ARDWICK GREEN

DESIGNERS RESPONSE TO ROAD SAFETY AUDIT

DESIGNERS RESPONSE TO ROAD SAFETY AUDIT

Revised S278 drawings

KERBING AND PAVING GA

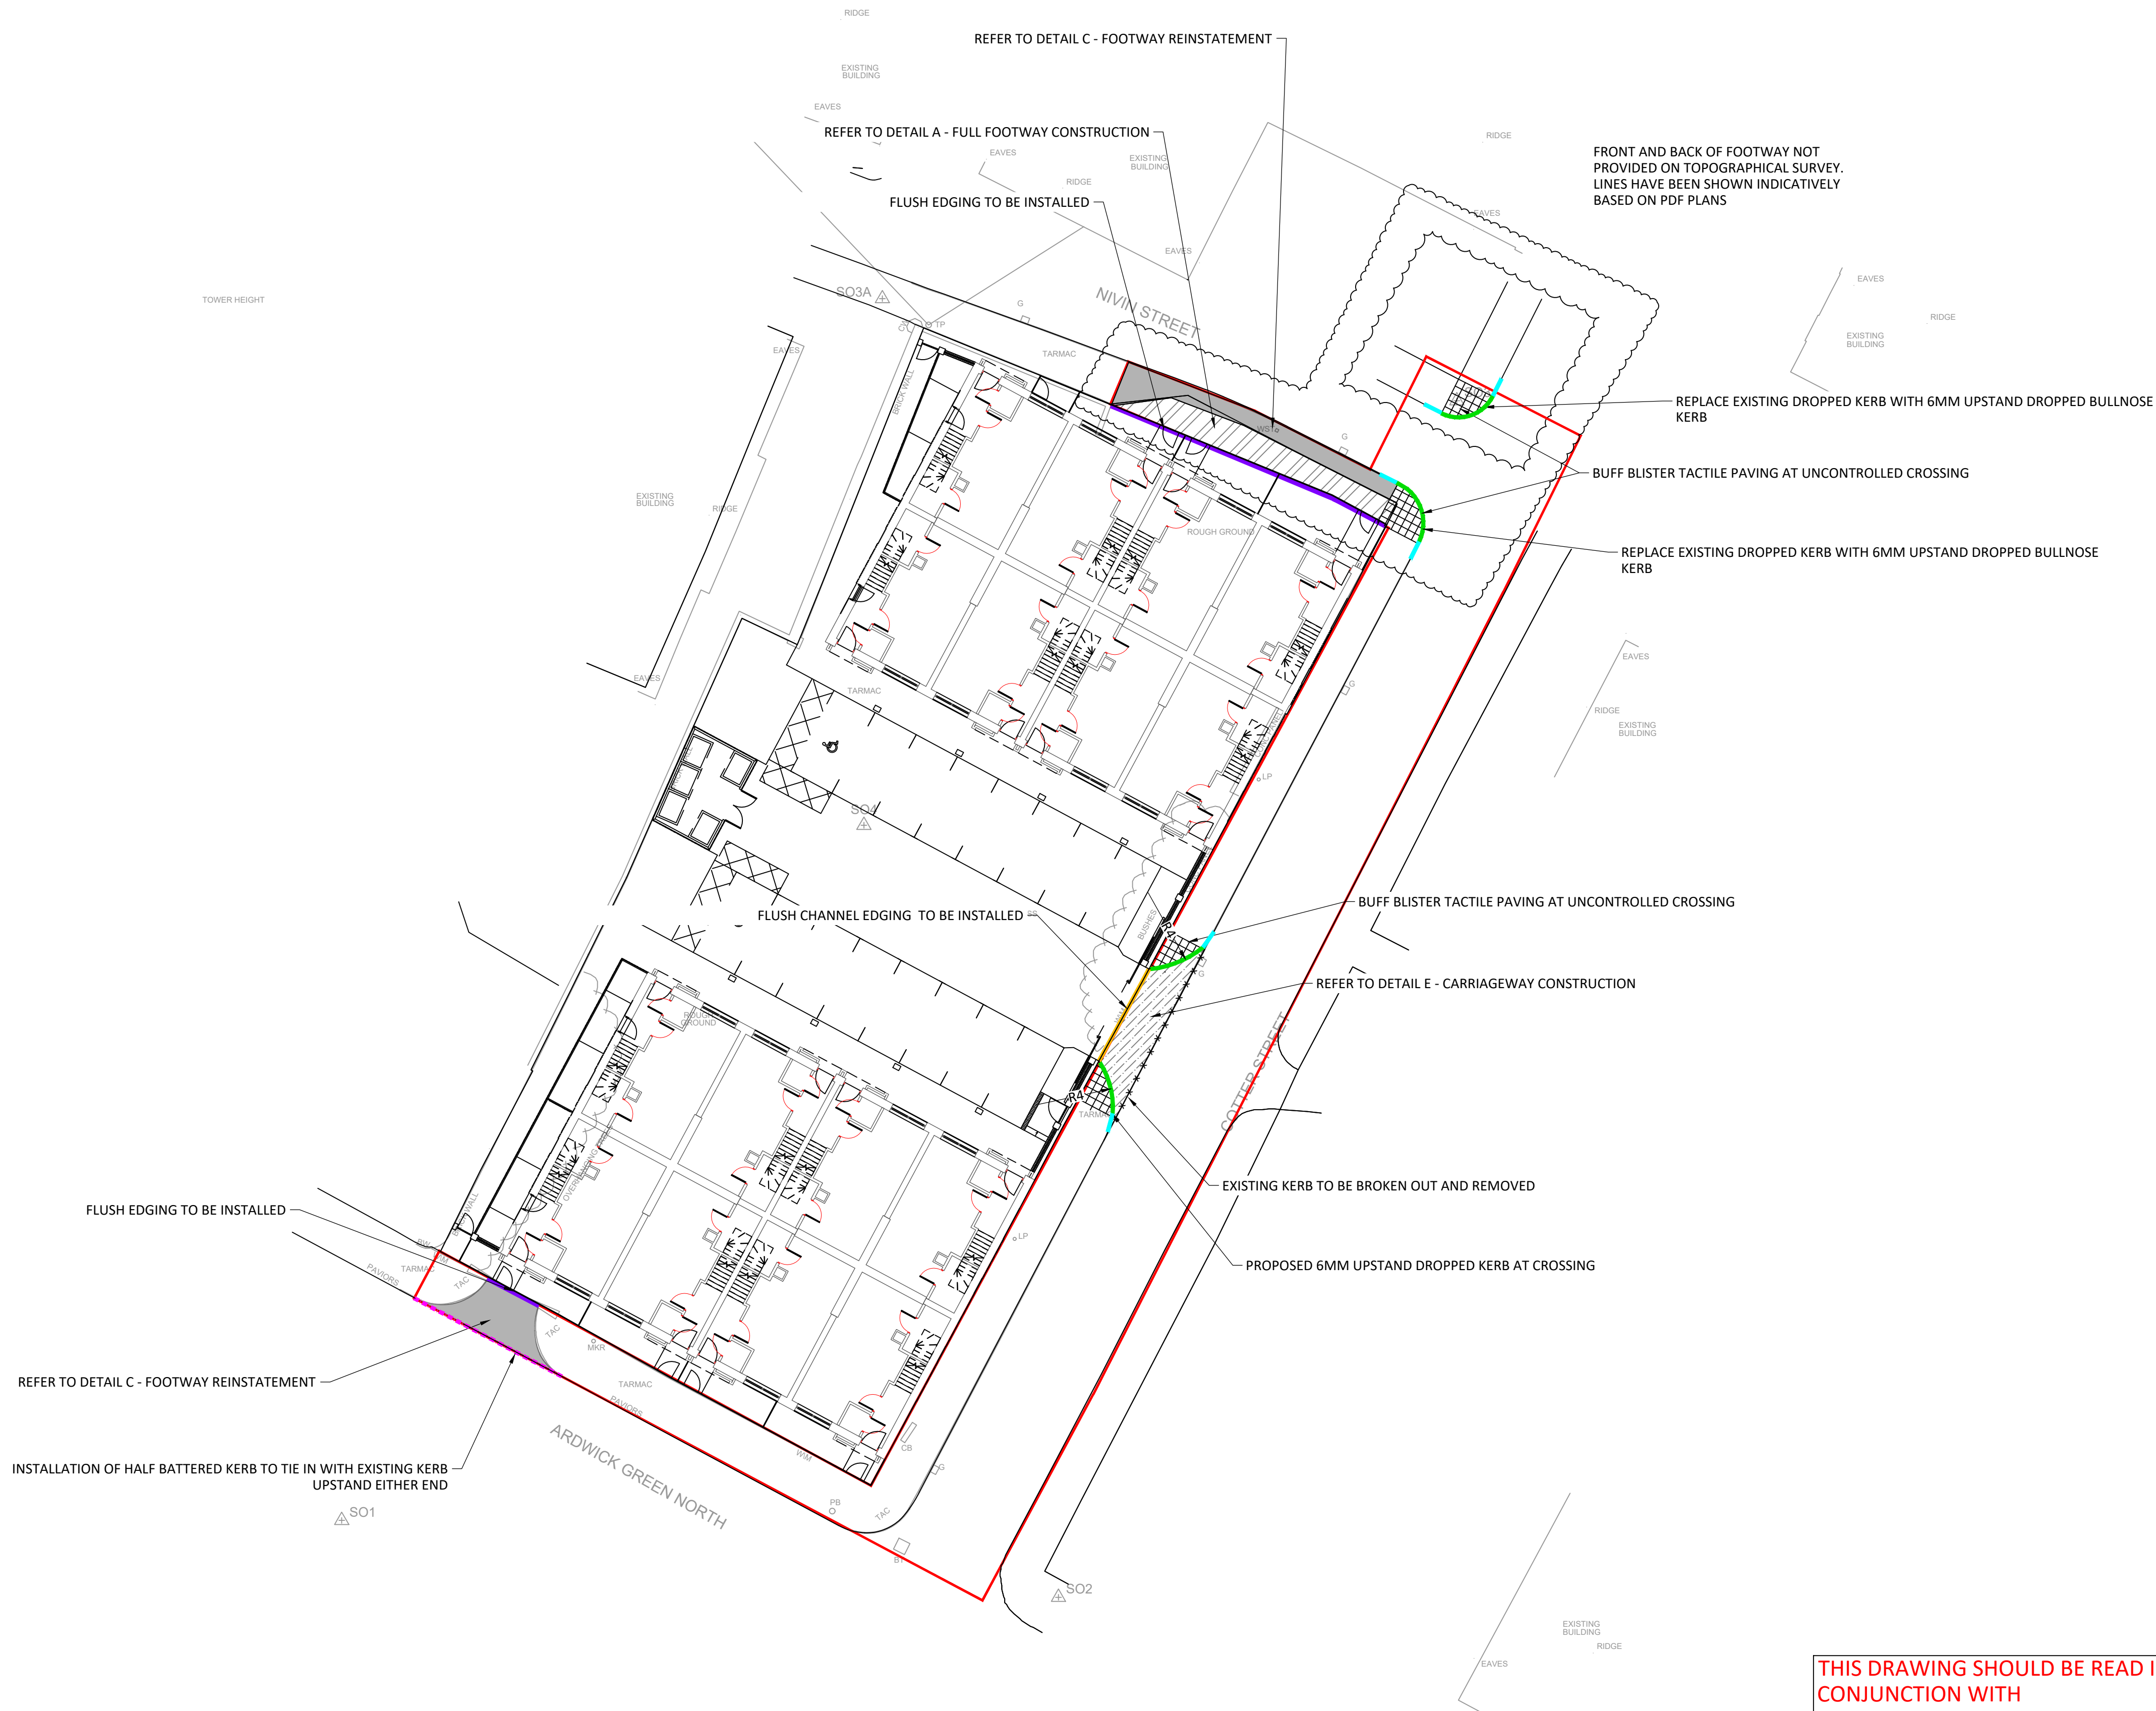
2.1.1. Location: Nivin Street at its junction with Cotter Street

Problem: Lack of appropriate facilities for pedestrians resulting in pedestrian trips/falls or pedestrian/vehicle collisions.

Summary: It was observed during the site visit that the kerb upstands at the existing uncontrolled pedestrian crossings on Nivin Street at its junction with Cotter Street were in excess of 6mm. Generally, the kerb upstand at uncontrolled pedestrian crossings is between 0mm and 6mm. The excessive kerb upstand may increase the risk of pedestrian trips/falls and may create manoeuvrability issues for those with pushchairs, wheelchairs and mobility scooters. Additionally, it was observed that there was no tactile paving in place at the existing uncontrolled pedestrian crossings, which may result in a lack of appropriate warning for visually impaired pedestrians of the side road, and they may inadvertently enter the carriageway, which could increase the risk pedestrian/vehicular collisions. It is noted that this is an existing issue, however, the proposed new development may increase the use of the uncontrolled pedestrian crossings.

Recommendation: It is recommended that the kerb upstands at the existing uncontrolled pedestrian crossings are reduced to between 0mm and 6mm, and tactile paving is also provided.

Design Organisation Response: Accepted - Drawings have been updated to show tactile paving at the existing crossing and a 6mm upstand. Please refer to drawings within Appendix A

2.1.2. Location: Proposed uncontrolled pedestrian crossing on Cotter Street

Problem: Incorrect tactile paving layout increases the risk of visually impaired pedestrians inadvertently entering the carriageway and potentially being struck by a vehicle

Summary: The proposed uncontrolled pedestrian crossing on Cotter Street at the proposed site access junction does not have the required minimum depth of tactile paving across the whole width of the dropped kerbs for an in-line type uncontrolled crossing. The audit team note that the minimum depth of tactile paving for in-line type crossings is generally 1200mm. A reduced depth of tactile paving results in a lack of appropriate warning for visually impaired pedestrians of the side road ahead and they may inadvertently enter the carriageway, which may increase the risk pedestrian/vehicular collisions.

Recommendation: It is recommended that the tactile paving layout should be amended to provide a minimum depth of 1200mm tactile paving across the whole width of the dropped kerbs at the in-line uncontrolled crossings.

Design Organisation Response: Not accepted - Due to the constrained layout of the footway, extending the blister paving to a minimum of 1200mm depth would result in the blister paving being laid directly against full height kerbs potentially introducing a hazard to visually impaired users. We therefore proposed to retain the paving layout as currently drawn.
